Questions by the TAAM delegation of the Netherlands
RDW-TAAM-2020-01

Directive or Regulation number:
ECE R125.01 suppl. 1

Subject:
Augmented Reality (AR) in the transparent area of the windscreen other than Head Up Display (HUD)

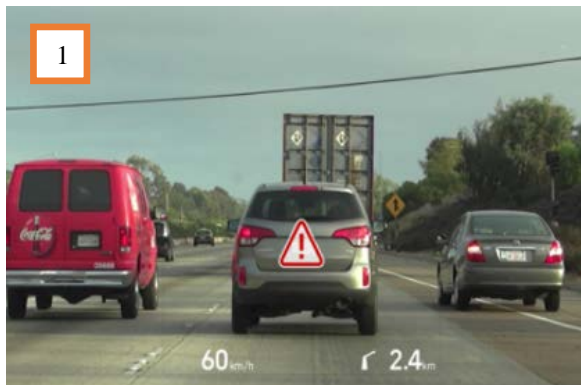
Paragraph 5.1.3. states that it is not allowed to have any obstructions in the direct field of vision other than those described. With new developments like Augmented Reality projections, new possibilities rise but how does this fit within the Regulation? Some examples:

As the images show, the system is projecting information in the transparent area of the windscreen. These projections vary in transparency and may or may not block direct vision. A proposal for the 02 series of amendments of UN Regulation No. 125 has been submitted to GRSG (ECE/TRANS/WP.29/GRSG/2020/12) to include the requirements for a so called “Field of Vision Assistant” (FVA); this proposal is to be discussed during next GRSG (potentially July 2020)

1. Do you consider these projections “obstructions” as described in article 5.1.3.?
2. Did you issue any WVTA according to 2007/46 with a form of Augmented Reality ?
3. If the answer to Q2 is yes, what were the conditions of approval ?
4. If the answer to Q2 is no, why not ?

<i>Solution</i>	<i>Accepted</i>	<i>Refused</i>
A	X	
B		X

Decision Q2:		
<i>Solution</i>	<i>Accepted</i>	<i>Refused</i>
A		X
B	X	
C		X

Decision Q4:		
<i>Solution</i>	<i>Accepted</i>	<i>Refused</i>
A		
B	X	
C	X	
D	X

Remarks:
<p>This discussion does not relate to commonly known Head Up Displays (HUD): Visual information displayed in area "S" as defined in paragraph 5.1.3.4.</p> <p><u>At Question 1:</u> The Regulation does not give a clear definition of obstruction, but does clearly indicate what is not considered as obstruction (see paragraph 5.1.3.). One could consider everything else, incl. AR, as obstruction. Or one could say that nothing is obstructing but information is projected which is something else.</p> <p><u>At Question 2:</u> It could be that you don't consider AR as obstruction and therefore a manufacturer may not even discuss these with the TS/TAA, so vehicle types may have some form of AR without it being evaluated or being part of any separate Type Approval.</p> <p><u>At Question 3:</u> The possibilities are numerous; basically anything could be projected, from traffic signs, to visual instructions for navigation but also commercially oriented information like the logo of a fast food restaurant or construction market, when approaching it. What do you consider acceptable at this moment ?</p> <p><u>At Question 4:</u> Due to discussions about the HMI and what will actually help drivers rather than offering additional distractions, RDW feels it necessary to align the possible requirements for such systems with other TAA's before allowing them.</p>
